**SRG ENGINEERING, INC.**  
CONSULTING STRUCTURAL ENGINEERS

TRANSMITTAL SHEET

RE: **Big Moose Harley Addition** METHOD OF SHIPMENT: **1<sup>st</sup> class US mail**

FINAL REPORT OF SPECIAL INSPECTIONS

### FIELD REPORT #3

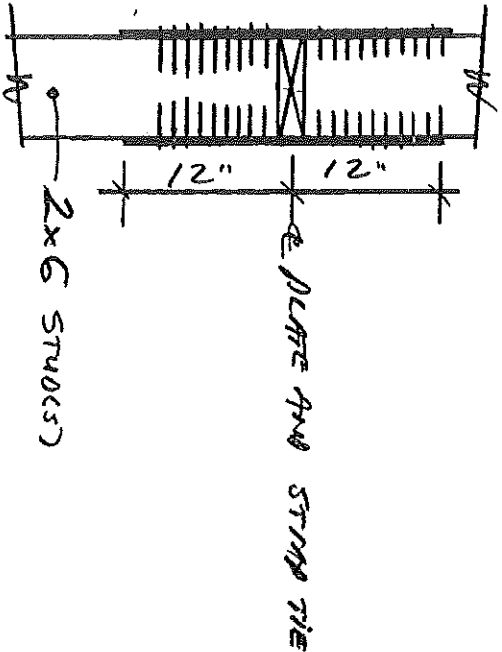
##### The following items need to be addressed:

1. There is a single 2x6 plate near the ridge (about 3ft down) spanning horizontally about 12ft. Studs are stopped above and below the plate. All studs at this plate location must have a 1 1/4" x 20 gage x 24" strap galvanized strap tie on each the outside and inside face of the stud. The strap must also be centered with the 2x6 plate. Provide at least (10) 8d nails at each end of each strap. Please see sketch below.
